Our Ref: DOC20/459634  
Your Ref: MP 06\_0143 MOD 4

**RE: Glades Estate Residential Subdivision (MP 06\_0143 MOD 4) – Response to Submissions**

**Attachment 1: Detailed BCD Comments – Glades Estate Residential Subdivision (MP 06\_0143 MOD 4) – Response to Submissions**

**Figure 1. Approved Bulk Earthworks Plan MP06\_0143 (on left). Figure 2. As proposed in original MOD 4 submission dated 9th April 2019 (on right).**

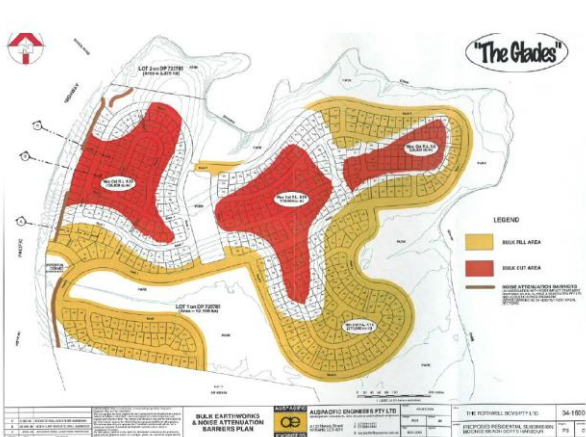
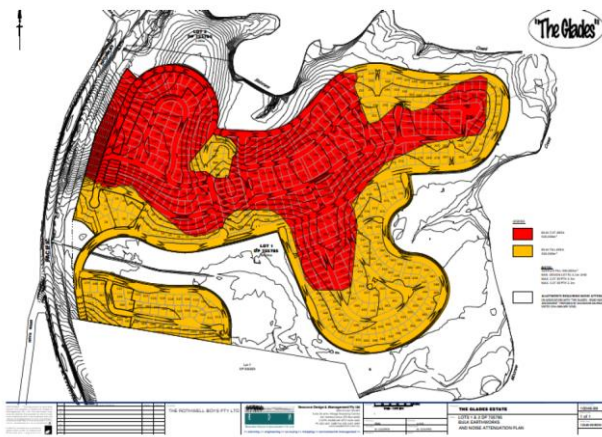
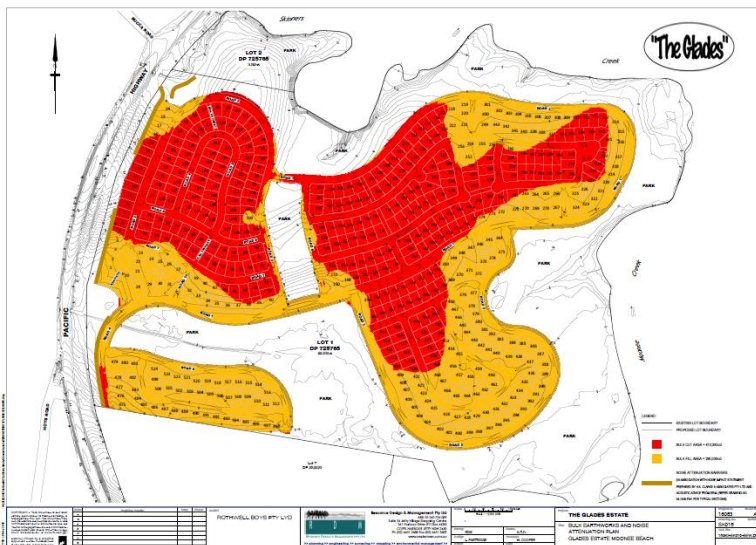
The BCD supports the retention of the central corridor as a wildlife corridor. However, we have several issues with the extent of cut and fill in its vicinity. A comparison of the earthworks plans is provided below:

The approved amount of cut was 274,000 m<sup>3</sup> (29,000 + 110,000 + 135,000) and 274,000 m<sup>3</sup> of fill. The proposed new Bulk Earthworks and Noise Attenuation Plan (Dwg No. SK 015) shows a bulk cut area of 470,000m<sup>3</sup> and a bulk fill area of 290,000m<sup>3</sup>. This proposal therefore has an additional 16,000 m<sup>3</sup> of fill. Most importantly, in terms of the retention and protection of the central corridor the extent of earthworks is much greater and extends to the retained corridor land. The plan showing the level differences between the approved plan and proposed plan (Dwg No. SK013) describes 0.5 to 1m of fill around the perimeter of the corridor (see Figure 4 below).

No assessment has been made about whether the proposed earthworks will impact on the retained central corridor or how impacts can be avoided and minimised.

1. The potential impacts of the proposed earthworks on the central wildlife corridor should be assessed and the works designed to undertaken to ensure there will no adverse impact on the corridor.
2. Planning and Assessment Group should review the following original conditions of consent to ensure that the proposed modification will not impact on the ability for these conditions to be fully met:
